From: Lopez, Ana
Sent: 16 March 2016 16:33
To: Gracie, Ian
Subject: Belsize Fire Station 2016/0745/P

Scheme Address	Belsize Fire Station, 36 Lancaster Grove, London, NW3 4PB
Planning Reference	2016/0745/P
Size of site (as stated on application form)	0.143 Ha
Date	11/03/2016
Recommendation:	Belsize Fire Station, 36 Lancaster Grove, London, NW3 4PB

Change of use of former fire station (Sui Generis) to provide 12 self-contained residential units (Class C3) including single storey side extension and insertion of roof dormers, with associated external alterations, landscaping and parking.

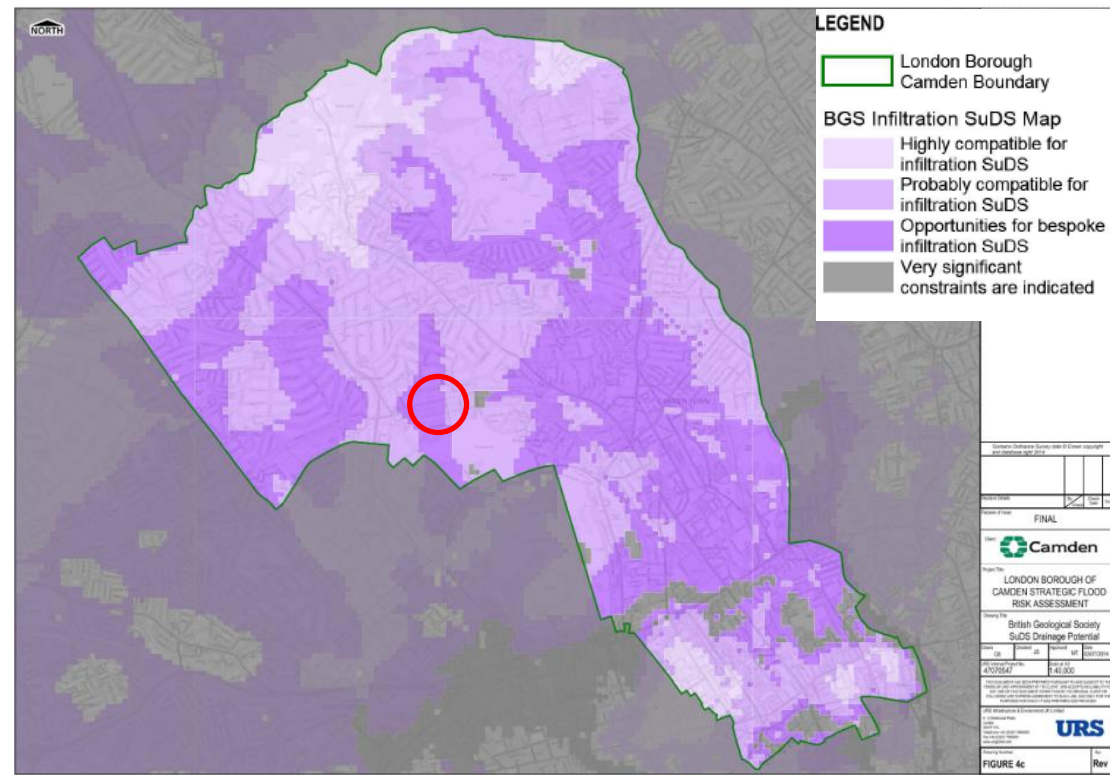
The applicant's SWDS states that as the site lies on London clay, infiltration techniques are not suitable; however the SFRA SuDS Drainage Potential map (see above) indicates that the ground conditions are probably compatible for infiltration SuDS or bespoke infiltration SuDS.

The current SuDS proforma and SWDS show that greenfield run-off rates (or 50% reduction in current run-off rates) have not been achieved. A number of SuDS techniques, in particular infiltration techniques, have been considered but deemed not feasible, however the SFRA SuDS Drainage Potential maps indicate that there is possible compatibility with infiltration SuDS techniques. There could also be consideration given to the addition of external soft landscaping.

Action for applicant: To further investigate infiltration SuDS techniques with the aim to meet Camden Development Policy targets, and to give further information on why some of the measures within the sustainable drainage hierarchy have not been proposed. To also give further details on SuDS proposals including size and location and maintenance plans.
